## DEPARTMENT OF PLANNING AND ZONING

June 27, 2013

### **Re: Southern Towers (DSUP2013-0006) Completeness Comments**

City staff has completed review of the materials submitted for the referenced Completeness Plan and has deemed the plan set incomplete. Furthermore, Condition #29, the submission of a revision to the design guidelines was to be satisfied 30 days after the April 13th approval by City Council. This condition needs to be satisfied prior to your next submission. The attached comments are based upon the submitted plan set dated June 6, 2013. Please respond to each of the attached comments in writing and revise the plans as necessary as part of the Preliminary Plan Verification of Completeness submission.

Image 5: VAWC Water map depicting existing conditions of the project area for reference only.

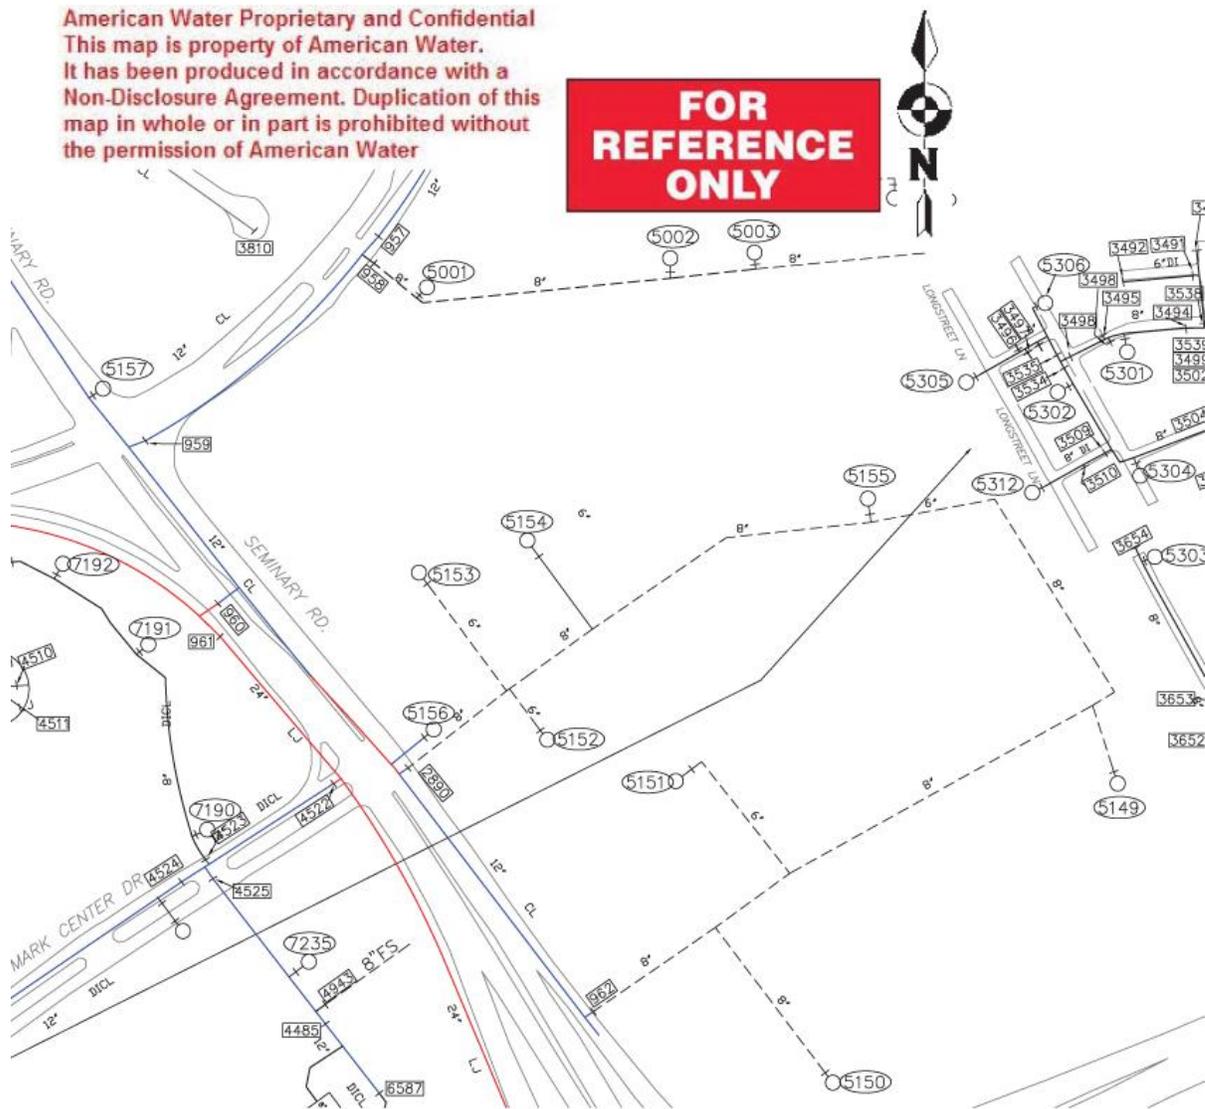
51. The existing water lines located inside the property are private. So, the proposed water line and fire hydrant will be private too. Please revise the annotations to indicate they are private.
52. Do not use 3" or 10" pipe. The standard size shall be copper (Type L/K, 3/4", 1", 1.5", and 2") or DICL (ductile iron cement lining, 4", 6", 8", 12", 16" etc.).

53. Please see attached water map for reference.
